Errata

Critique of Turbulence Models for Shock-Induced Flow Separation

[AIAAJ 27, 1648-1650 (1989)]

Theory for Radial Jet Reattachment Flow

Fig. 1 Suggested flow field characteristics at Mach 3 for a 60 deg swept 23 deg compression corner.

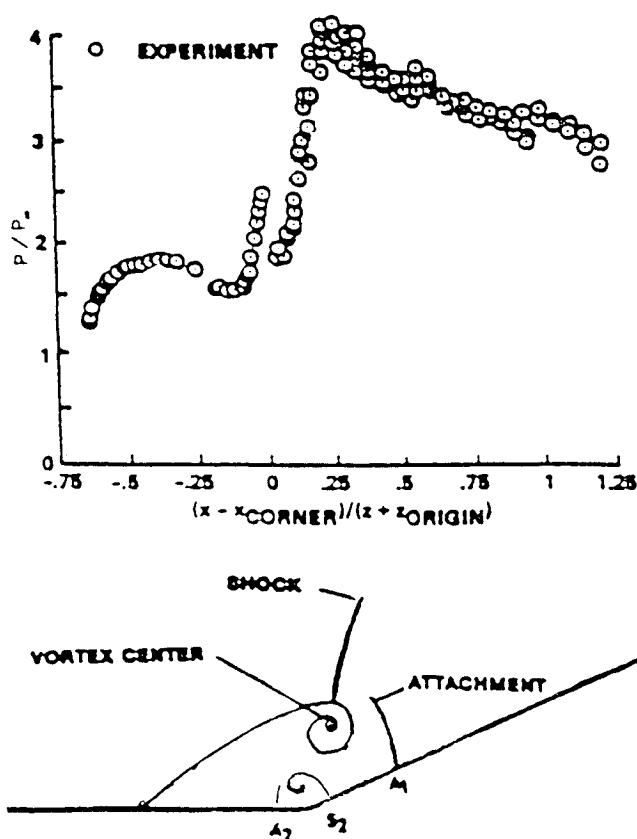
AS a result of correspondence from Hung,¹ the author discovered that the flow geometry sketched in Fig. 6 was not properly aligned with the pressure distribution. The correct geometry is shown in Fig. 1.
